State of California  
Department of Water Resources  
Sustainable Groundwater Management Program  
Alternative Assessment Staff Report

Groundwater Basin Name: Corralitos – Pajaro Valley (Basin No. 3-002.01)  
Submitting Agency: Pajaro Valley Water Management Agency  
Recommendation: Approve  
Date Issued: July 17, 2019

Figure 1. Pajaro Valley Subbasin, PVMA jurisdiction, and PVHM model grid

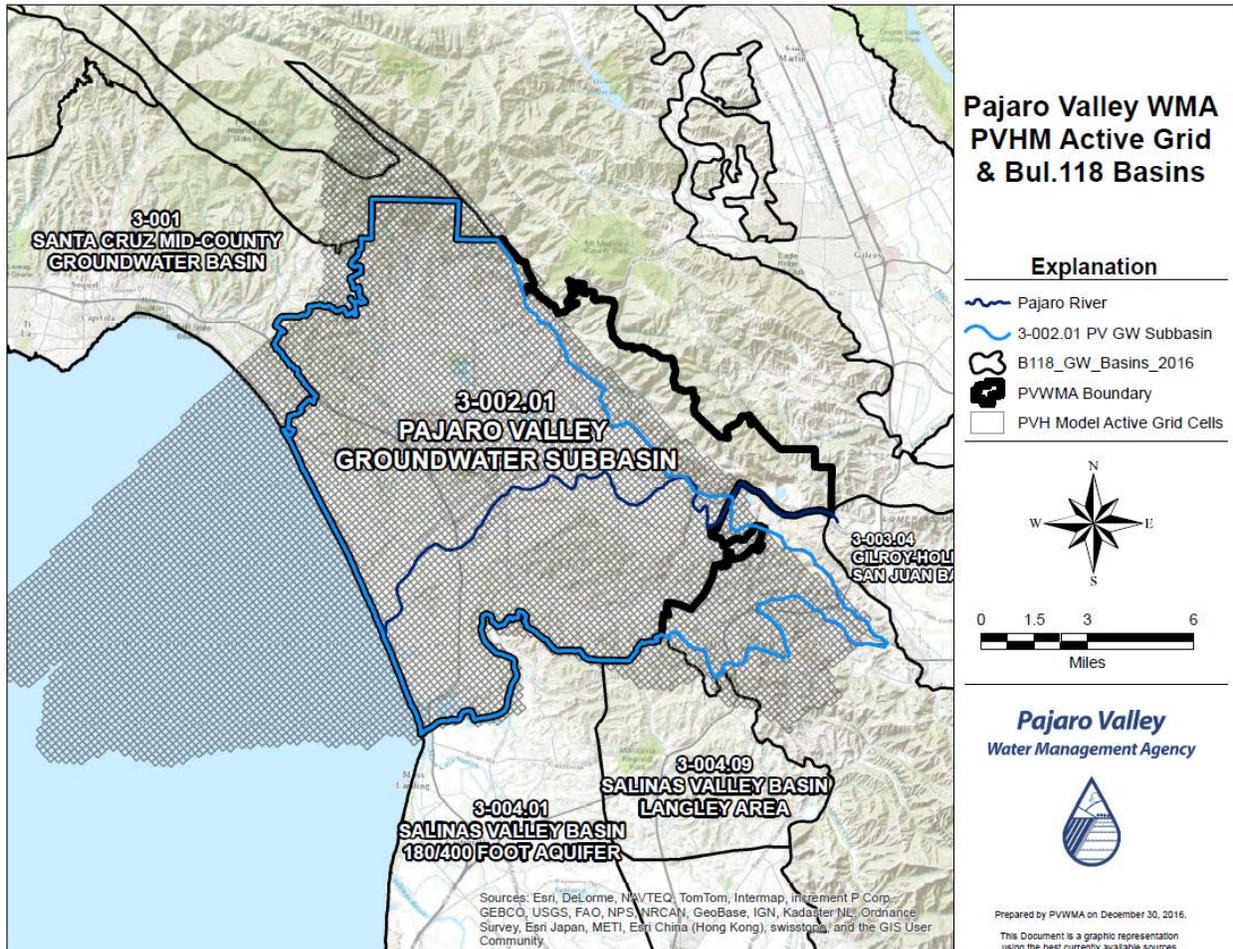
Although Department staff have determined that the Pajaro Subbasin Alternative satisfies the objectives of SGMA (see Assessment, below), the Pajaro Valley Subbasin is not yet sustainably managed. As a result, the Alternative cannot be said to effectively cover the entire Subbasin based on the current avoidance of undesirable results. Instead, staff considered whether the geology and hydrology of the non-jurisdictional area is adequately understood and whether groundwater usage in that area would or would not adversely affect the jurisdictional portion of the Subbasin, and *vice versa*. Staff also considered whether the non-jurisdictional area is or is not experiencing undesirable results or that implementation of the Alternative would result in the avoidance of undesirable results in the non-jurisdictional area.

The Agency's understanding of hydrologic conditions in the Pajaro Valley Subbasin is demonstrated in the PVHM Report, which presents a hydrogeologic and numerical groundwater model that covers nearly the entire Subbasin and significant areas outside

of the Subbasin, as shown in the map above.<sup>35</sup> The area covered by the model, denoted by the hatched pattern on the map, includes virtually the entire area outside the Agency boundaries to the south. Modeling results presented in the PVHM Report, which simulated groundwater levels from 1987 to 2009, show that groundwater levels in the non-jurisdictional portion of the Subbasin did not exhibit declining groundwater levels.<sup>36</sup> This was in contrast to the overdraft conditions experienced in the main (jurisdictional) part of the Subbasin, which conditions motivated development of the Basin Management Plan.

Staff recommend that the Agency define how it will assess, on an ongoing basis, the non-jurisdictional portion of the Subbasin and demonstrate that activities in that area are not adversely impacting successful implementation of the Plan within the Agency's jurisdictional area, or adversely affected by implementation of the Plan or by groundwater use in the area not subject to that Plan. That assessment may include, but is not limited to, additional monitoring in the non-jurisdictional areas and agreements with other entities.
